**Ridgefield Road Solar Farm
Project Review for Planning and Zoning Commission**

Meeting Date: September 6, 2023

Request: Conceptual Planned Unit Development for a solar farm.

Location: Ridgefield Road

Site Layout

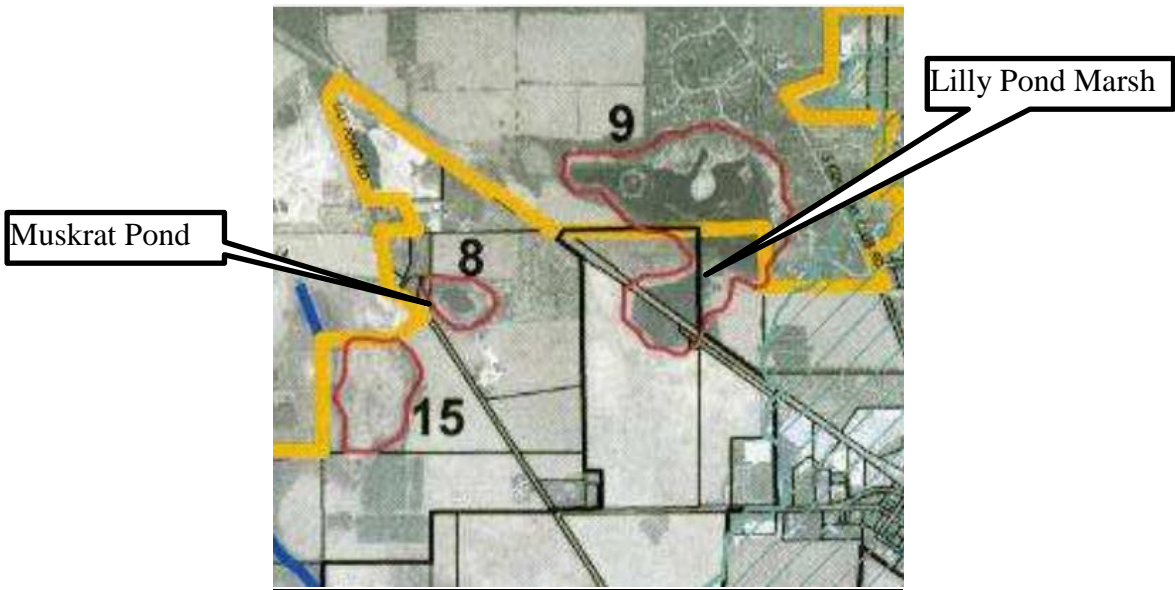
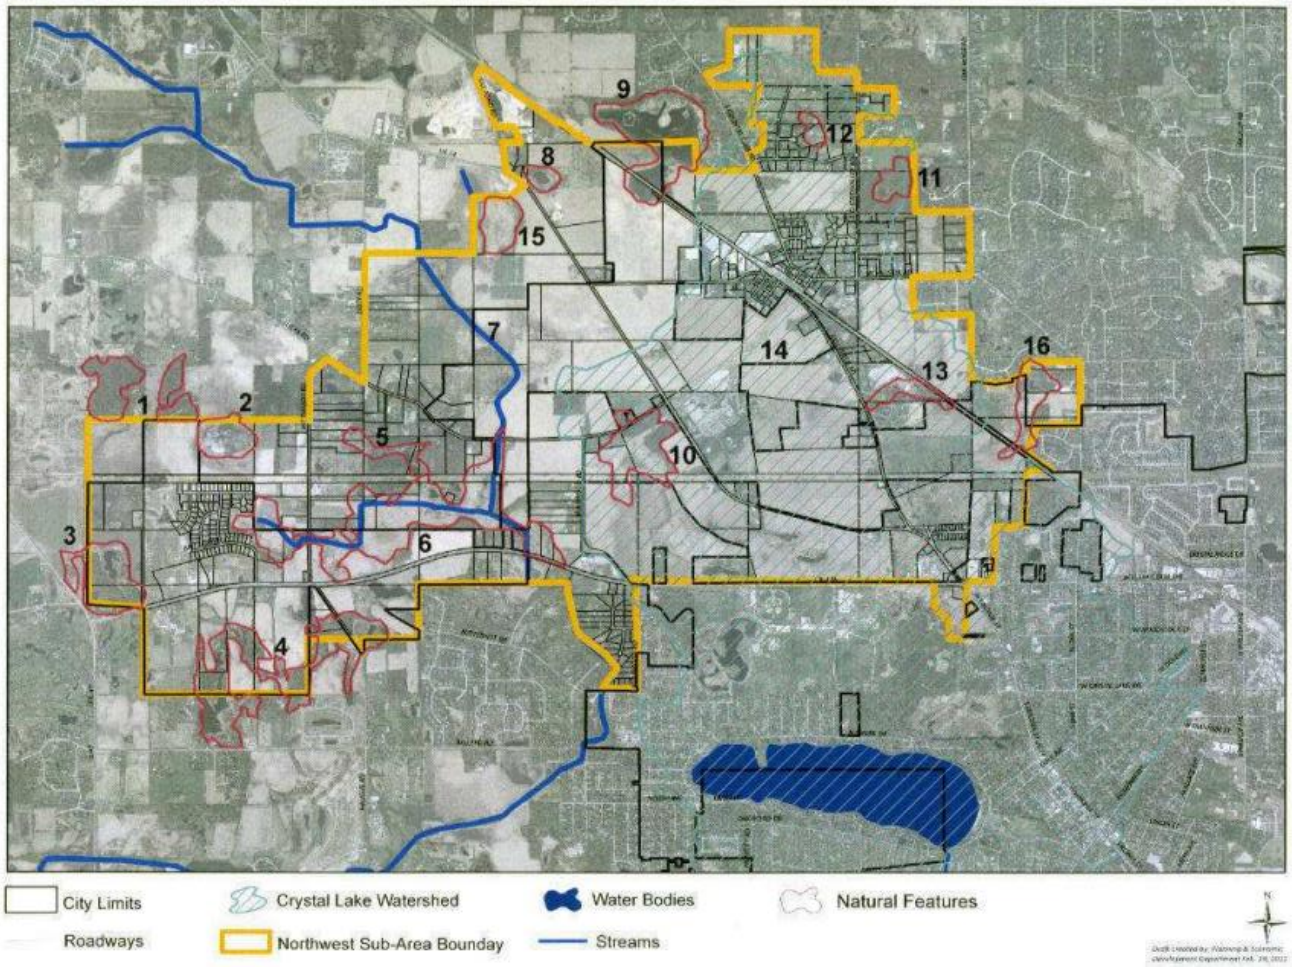
- The site would be accessed from Ridgefield Road, just west of the MAC and the soccer fields.
- The solar farm is approximately 1,000 feet from Ridgefield Road.
- A 10-foot paved path would run throughout the site. This is to comply with the UDO requirement for solar farms.
- A green fabric-wrapped fence is proposed around the entire site. This is to comply with the UDO requirement to screen the solar farm from roadways.
- The UDO requires that the grounds in and around the panels shall be repurposed for wildflowers or agriculture. A landscape plan would be required with the Planned Unit Development submittal.

Northwest Sub-Area Natural Features

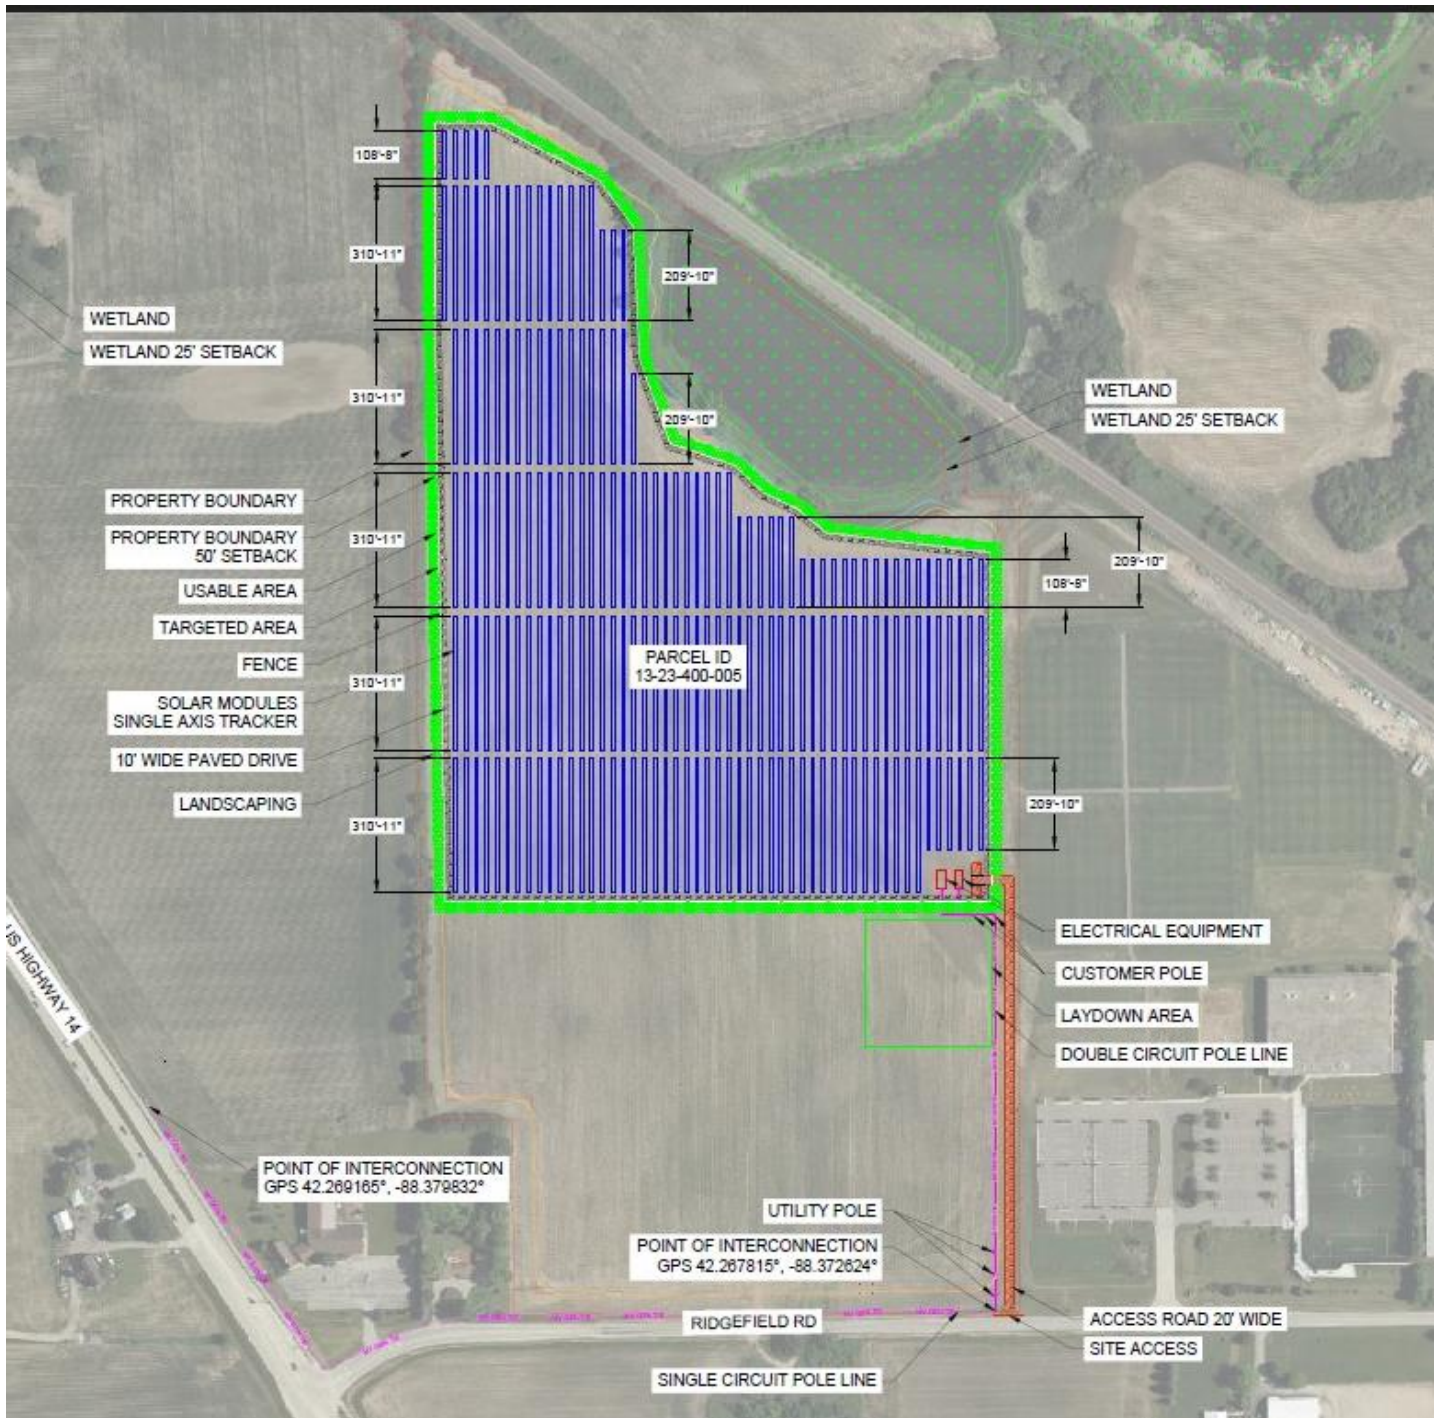
- The wetland is Lilly Pond Marsh and per the Comprehensive Land Use Plan, a 100-foot buffer is required.
- There is an opportunity to provide a green path along the railroad right-of-way to start a connection over to Muskrat Pond to the west.
- A wetland delineation would be required for development.
- Comprehensive Land Use Plan recommendations:

- 8) Muskrat Pond, identified by MCCD, is a small pond surrounded by undisturbed bushes and grasses. A 100-foot buffer should be established from the outer limits of the grass area surrounding the pond.
- 9) Site 9 is Lily Pond Marsh, identified by MCCD. This feature straddles the rail line and a portion of this feature is located within the sub-area. This site has very little undisturbed surrounding area because it has been farmed. A 100-foot buffer should be established to protect the water quality of this feature. Opportunity exists to provide a green space connection between this site and site 8.
